Meeting Agenda Plat Committee

Monday, June 22, 2026

1. [KPB-7801](#) Carl & Emma Clark Estate No. 2; KPB File 2026-056
Johnson Surveying / Wilson
Location: MP 17 Hope Highway
Hope Area / Hope-Sunrise APC
Attachments: [E1. Carl & Emma Clark Estate No 2 Packet](#)
[E1. Carl & Emma Clark Estates No 2_Desk Packet](#)
[PHN Carl & Emma Clark Estate No 2](#)
2. [KPB-7802](#) Fritz Creek Drive No. 2 Sorensen; KPB File 2026-044
Mullikin Surveys / Sorensen
Location: Stuart Avenue & Sorensen Street
Fitz Creek Area
Attachments: [E2. Fritz Creek Dr. No. 2 Sorensen_Packet](#)
[PHN Fritz Creek Drive No 2 Sorensen](#)

KPB File 2026-056
T10N R02W SEC28, 32 & 33
Hope

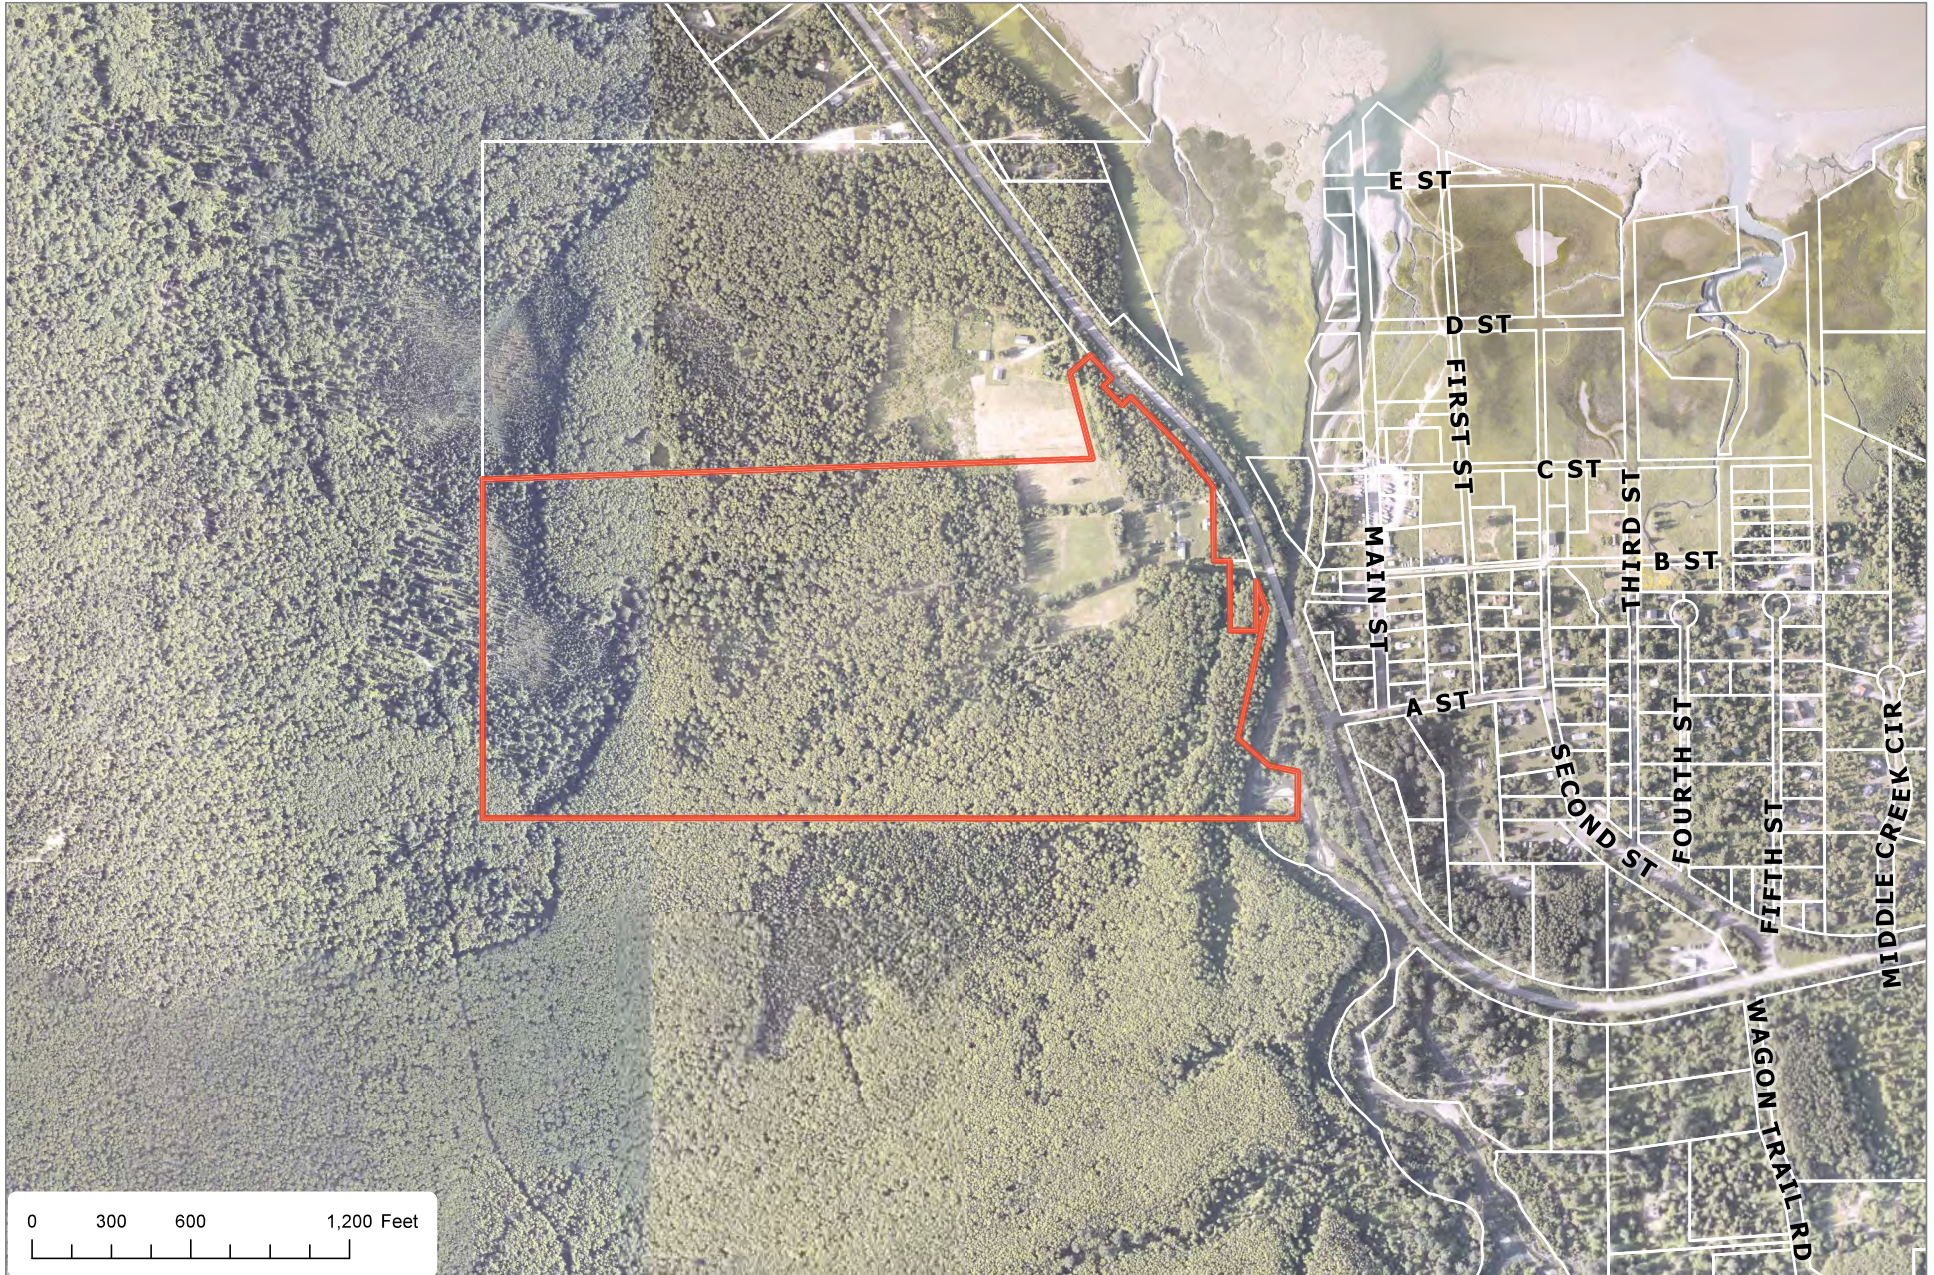
Based on available imagery and USS 1092 (HES 71), a trail extends from the southern boundary of Tract B2 through Tract B1 into the Chugach National Forest. **Staff recommends** the applicant verify whether the trail will be granted as an easement or labeled as a private trail.

KPB records indicate no section line easements affecting the subject area. The certificate to plat notes that the property is subject to a section line easement at item #12. Available information indicates entry on the property occurred in 1915, with the patent issued in 1922. Any concerns regarding the status of the section lines easement may be determined by the State of Alaska DNR. **Staff recommends** the applicant verify the status of the section

Based on available imagery and KPB Assessing records, proposed Tract B2 contains improvements. **Staff recommends** the surveyor verify that no encroachments will be created by the placement of the new lot line.

- o Correct the minor typo in the Wastewater Disposal Note by moving the period "...onsite wastewater treatment and disposal."
- o In the Flood Hazard Notice, correct the spelling of area in flood hazard area district.
- o Solid square is not shown in legend, please add.

- The borough will not enforce private covenants, easements, or deed restrictions per KPB 20.60.170(B).
- Acceptance of this plat by the Borough does not indicate acceptance of any encroachments.
- Add reference to the access easement to the private cemetery listed in BK 110 PG 823
- Add the easement in Bk 45R Pg 169 to the plat notes

- o Add SE1/4 Section 29 to legal description
- o Add KPB File No 2026-056
- o Change 'prepared for' to 'Owner'

- Depict and label the section lines and sections on the drawing: S29, S28, S33, and S32
- D. A vicinity map, drawn to scale showing location of proposed subdivision, north arrow if different from plat orientation, township and range, section lines, roads, political boundaries, and prominent natural and manmade features, such as shorelines or streams;
Staff recommendation:

- Add CTP items #9, #11 and #12
- F. The location, width and name of existing and platted streets and public ways, railroad rights-of-way, easements, and travel ways existing and proposed, within the subdivision;
Staff recommendation:
There appear to be trails crossing the plat into the Chugach National Forest shown on the Survey No 1092. Identify trails as public or private on the drawing.

- Provide a label to the south “unsubdivided”
 - Modify the labels for the parcels abutting the subdivision to the east for clarity purpose: Hope Ranger Station and Hope Cemetery (USS 1092)

- Kettle shown on preliminary plat as “swamp”. Modify label to “low wet areas” and within the legend, provide source of wetland determination.
- N. Apparent encroachments, with a statement indicating how the encroachments will be resolved prior to final plat approval;
Staff recommendation:

- 2. Fritz Creek Drive No. 2 Sorensen; KPB File 2026-044
Mullikin Surveys / Sorensen
Location: Stuart Avenue & Sorensen Street
Fitz Creek Area**

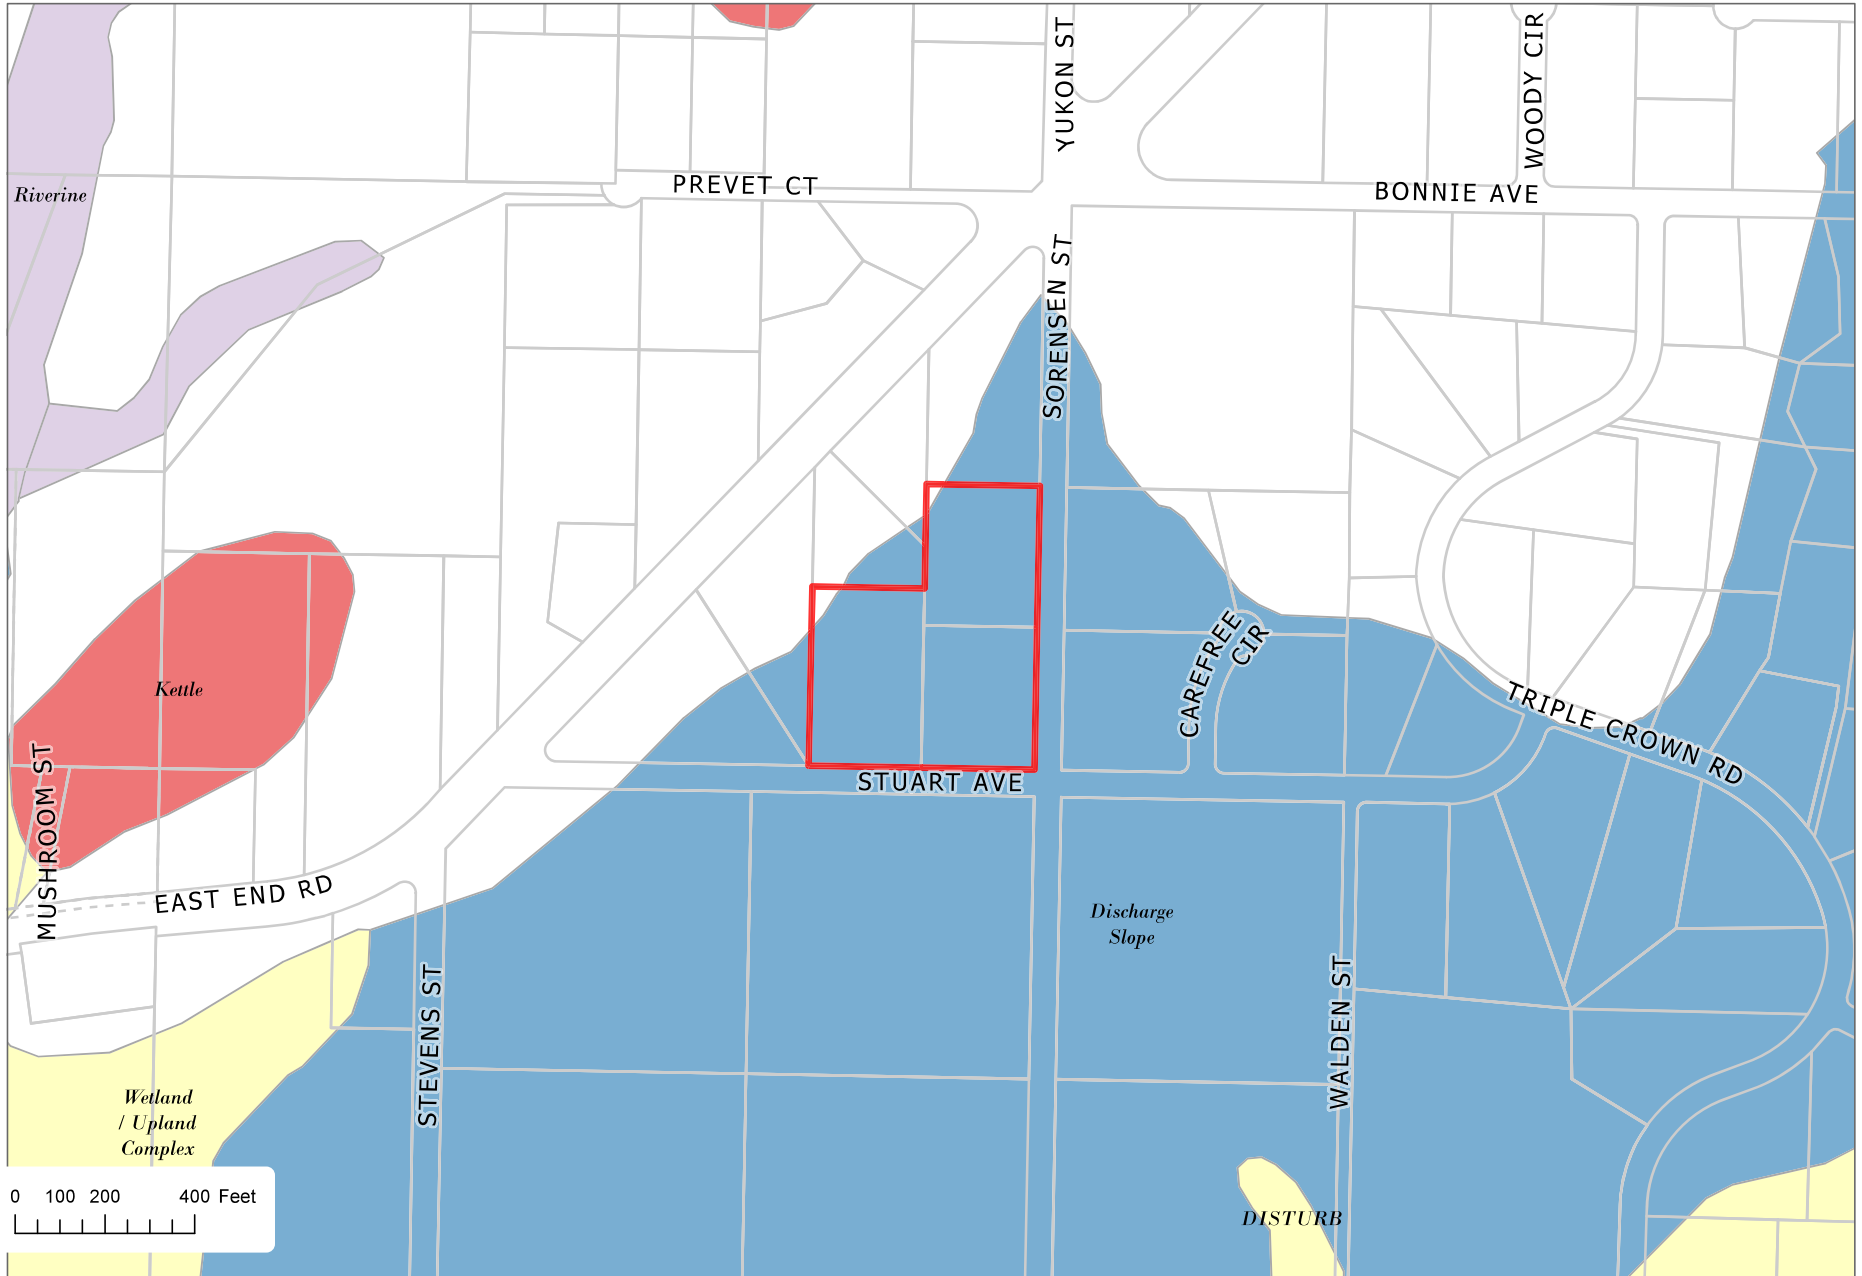
to verify the location of the structure and determined that no permanent structures encroach on the property lines. A small portion of the driveway appears to cross the property line of Lot 7-A near the connection to Sorensen Street.

- Modify the plat approval date to June 22, 2026.
- Within plat note 6, add a space between “wetland determination.”
- Change “Wastewater Certificate” to “Wastewater Disposal.”
- Identify which reference plat applies to dimensions given.
- C1/4 corner per HM80-101 and HM2007-50 has the year 1968 shown on it. Please correct.

- 3. Doyle Estates Subdivision Seventh Addition; KPB File 2026-055
McLane Consulting Group / Doyle Family Revocable Trust
Location: Dalton Street S & Karik Avenue
Kalifornsky Area**

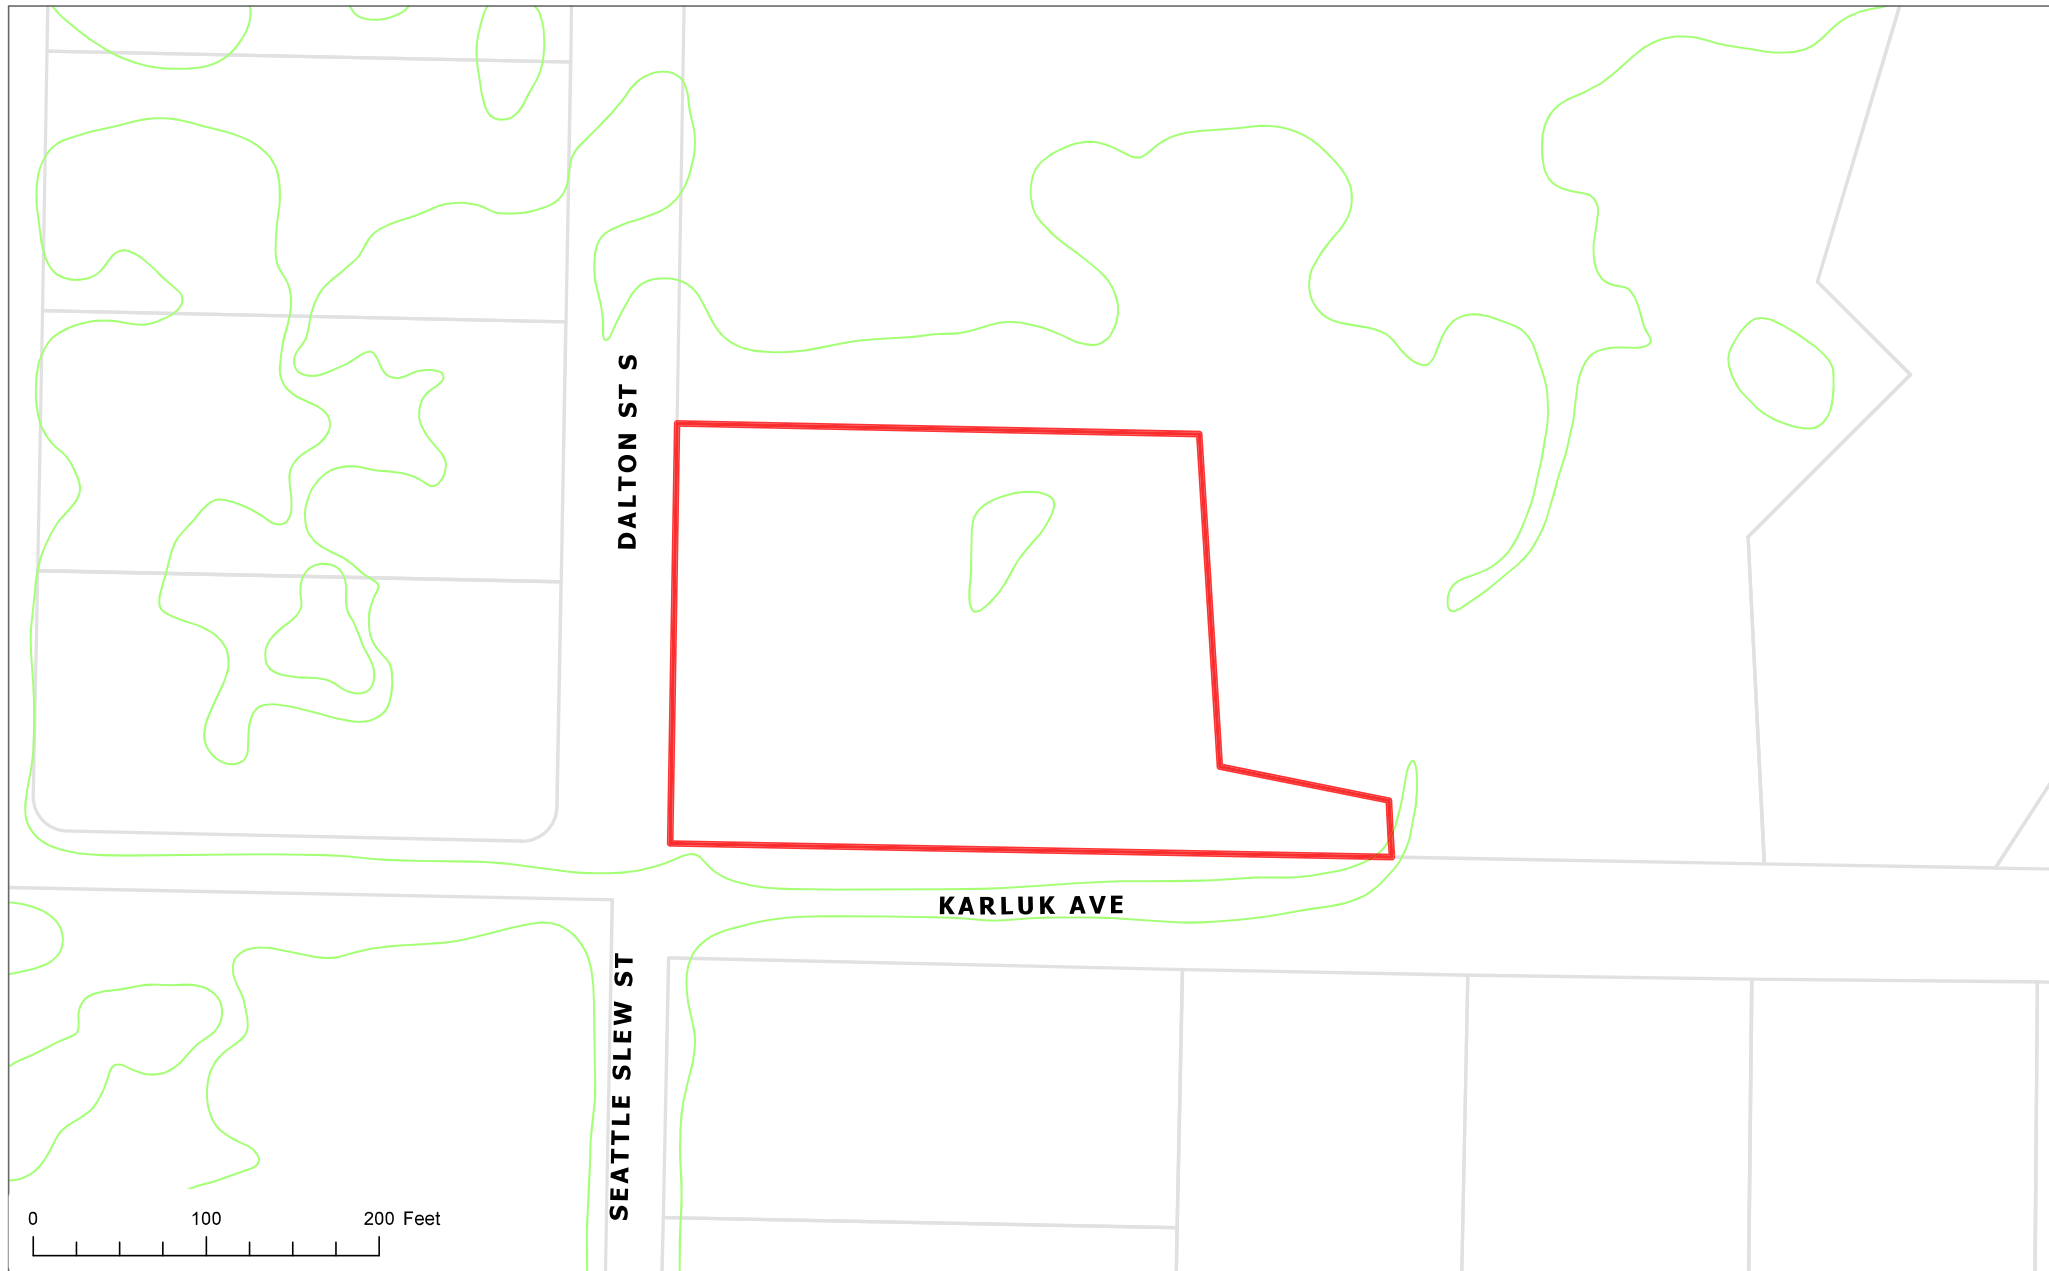
There are 33’ section line easements on both the west and south section lines adjacent to the plat. Staff recommends the surveyor verify the width of the section line easement and show the section line easement on drawing.

Easements of record are shown on the drawing, but need to be labeled.
